SLO Valley Basin Groundwater Sustainability (GSP) Public Comments

Last Updated: 03/25/21

Re: NOAA's National Marine Fisheries Service comments on the draft Groundwater Sustainability Plan (Chapter 5) for the San Luis Obispo Valley Groundwater Basin

NOAA's National Marine Fisheries Service's Comments on the draft Groundwater Sustainability Plan (Chapter 5) for the San Luis Obispo Valley Groundwater Basin (March 2020)

Figure 1. San Luis Obispo Creek Intrinsic Potential Steelhead Spawning and Rearing Habitat.

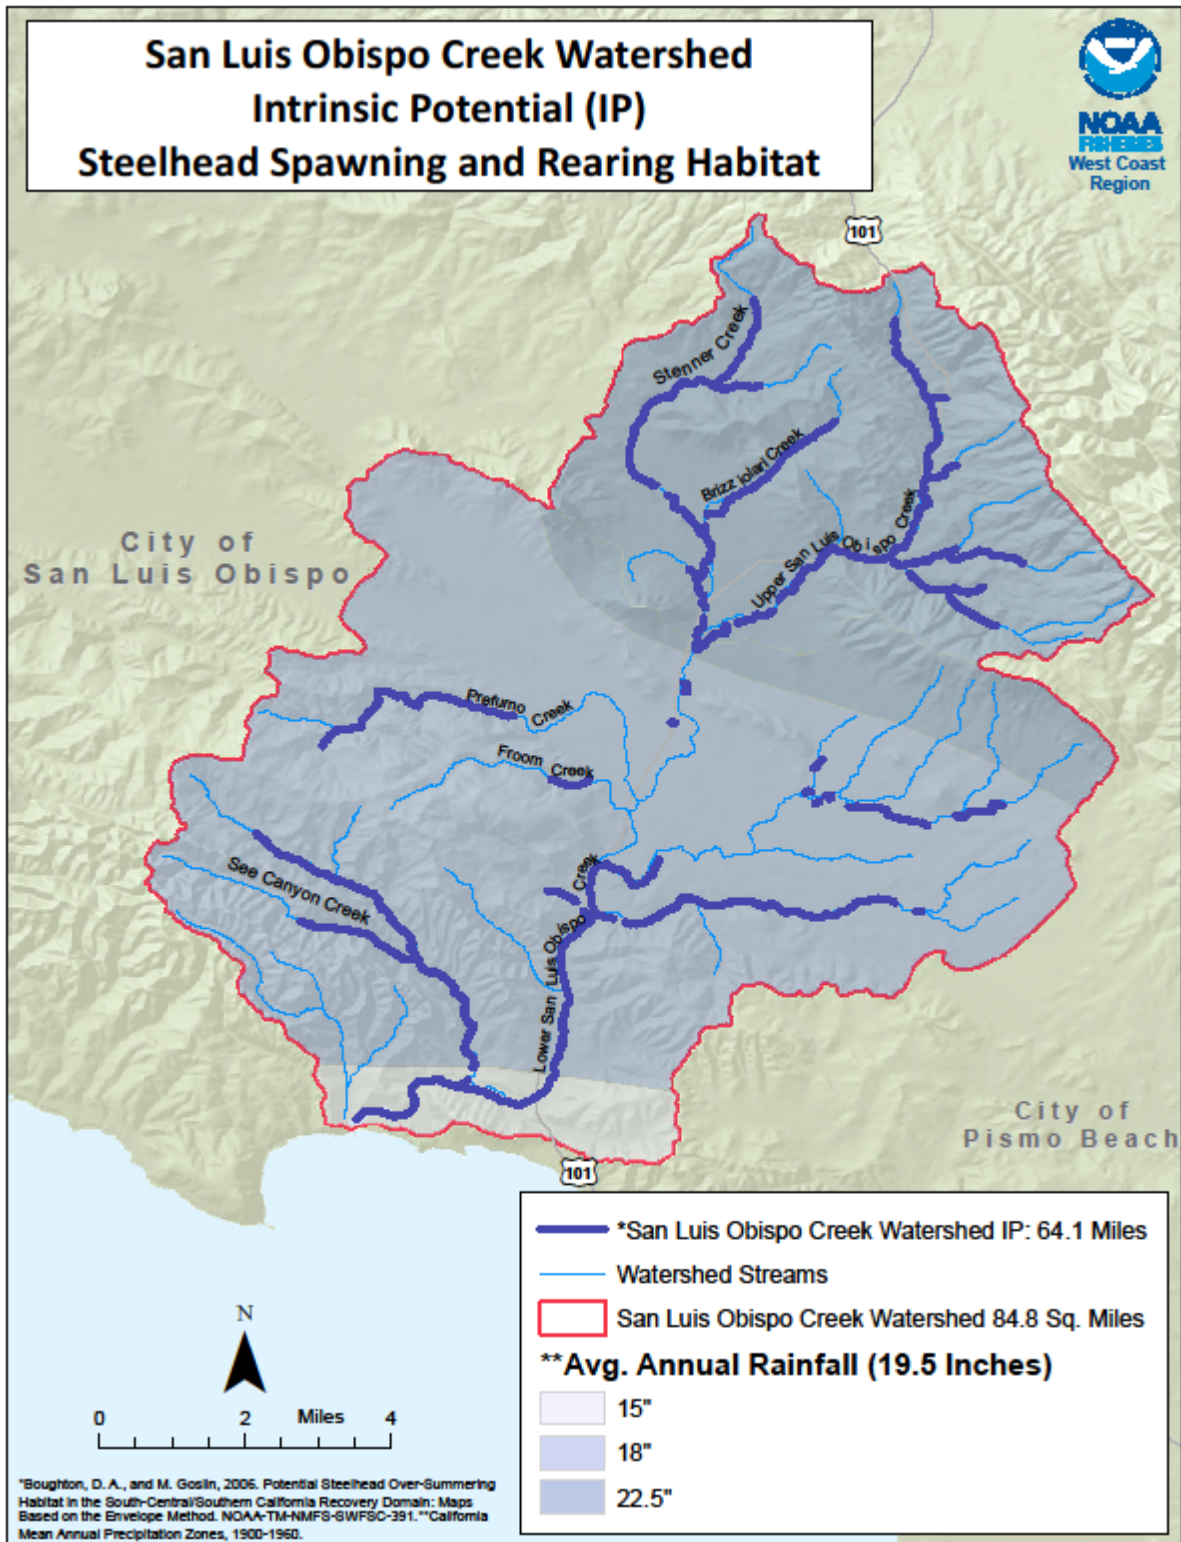
steelhead based on the amount of potential habitat (in an unimpaired state) in each watershed within the SC-CCS DPS. See Figure 1 and 2, “Intrinsic Potential Steelhead Spawning and Rearing Habitat maps for San Luis Obispo Creek and Pismo Creek included as part of Enclosure

Critical habitat throughout the threatened SC-CCS DPS of steelhead has been adversely affected by loss and modification of primary constituent elements (substrate, water quality and quantity, water temperature, channel morphology and complexity, riparian vegetation, passage conditions, etc.) through activities such as groundwater extractions and related surface-water diversions (NMFS 2013). Thus many of the constituent elements of critical habitats have been significantly degraded (and in some cases lost) in ways detrimental to the biological needs of steelhead. These habitat modifications have hindered the ability of designated critical habitat to provide for the survival and ultimately recovery of the threatened SC-CCS DPS of steelhead. See Figures 3 and 4, “Critical Steelhead Habitat maps for San Luis Obispo Creek and Pismo Creek included as part of this Enclosure.
